BEFORE THE NEW PLYMOUTH DISTRICT COUNCIL INDEPENDENT HEARINGS COMMISSIONER

of the Land Use Resource Consent LUC21/47890 application for 1-3 Dawson St, New Plymouth

SUMMARY STATEMENT OF EVIDENCE OF BILL JACKSON ON BEHALF OF THE GROUP OF OBJECTORS - Refer section 6

23 September 2021

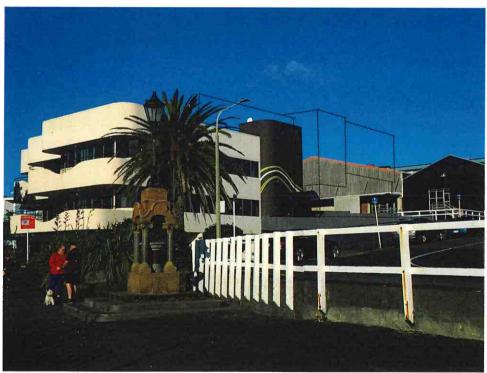
In this image I have marked up the windows as I believe they will actually look with tinted glass and in certain lights. (Notice the black look of the glass in the existing building.) The proposed building will appear heavier and more overbearing than depicted in the applicant's version of this image.

In this view the fountain is dominating, and the proposed building is cropped out disguising it's true bulk. Applicant's assessment: **Very low**

This view reveals the true bulk of the proposed building. My assessment: **Moderate adverse**

View E Hine street Applicants assessment: Low beneficial My assessment: Moderate adverse

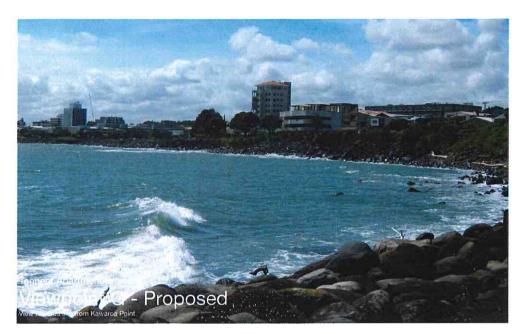
This view shows the true bulk of the proposed building.

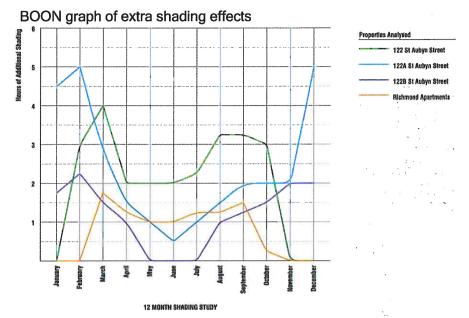
This summary shows that additional shading runs for 0.5 to 5.5 hrs, with 122 St Aubyn St, Diane and Bill Mc Arthur, and 122A, Colin and Margaret Comber, the most affected. 4 hrs and 5.0 hrs. This is also depicted in the BOON evidence page 71:

This shows that at any time, at least one of the objectors is affected for a min. of 2 hrs

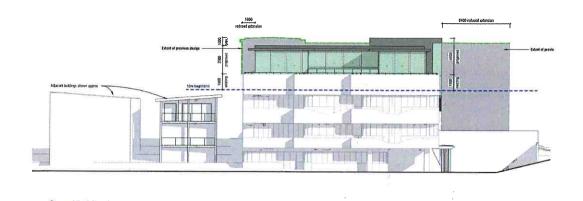
In my opinion, the proposed building pays little respect to the existing building in terms of line, level, composition, materiality or style.

It does not appear to be 'sympathetic in scale'.

There is no 'cohesive unification of the two'

The overall effect is one of striking dominance within the public streetscape.

This scale effect is particularly noticeable on the north elevation submitted, when compared with the existing 3 storied residence adjacent.

Marsland Hill view shaft

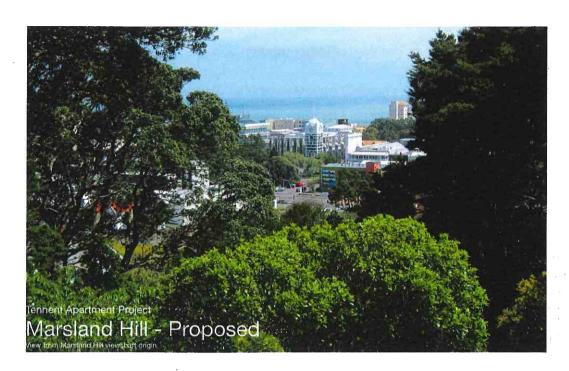
I do not concur with this assessment:

I say that the <u>core of the view is impinged upon</u> by the additional height of the proposed building, as clearly depicted by the applicant.

The proposal reduces the amount of sea visible by a noticeable amount. It actually does protrude above the office building immediately in front of it. The dark colour of the glass building stand out.

This point was also raised by the peer review, by Natural Capital item 4: What is illustrated by the montage within Appendix B, is how the dark colour used in the montage punctuates the centre or core of the scene where built form touches the sea. (Refer to the applicant's assessment photo.)

122 St Aubyn St - Bill & Diane Mc Arthur

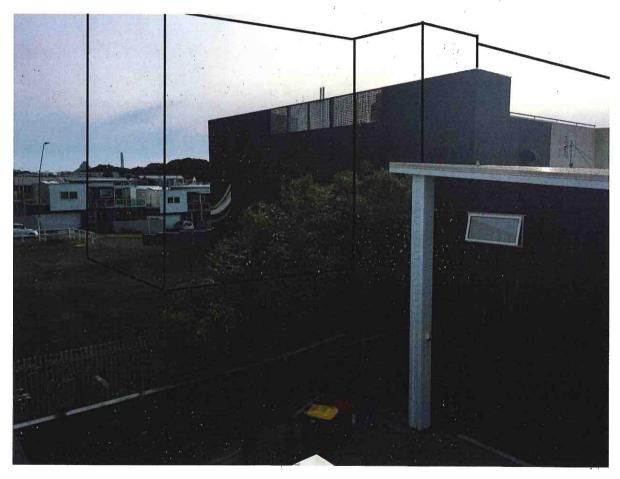
The most effected is first, 122 St Aubyn St - Bill & Diane Mc Arthur, and then the less affected with distance and elevation from the subject site.

These photos show the dominating visual amenity effect of the proposal, and the loss of sky space, particularly from the closer homes.

120 St Aubyn St Unit 1A Richmond Estate - Morris and Ria Hey

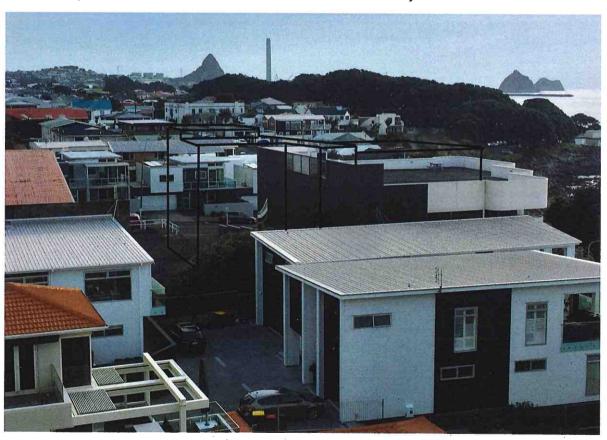
In the case of Unit 1A Richmond Estate - Morris and Ria Hey, there is a significant loss of views. In assessing these, the 'permitted baseline' is the line of the existing building parapet.
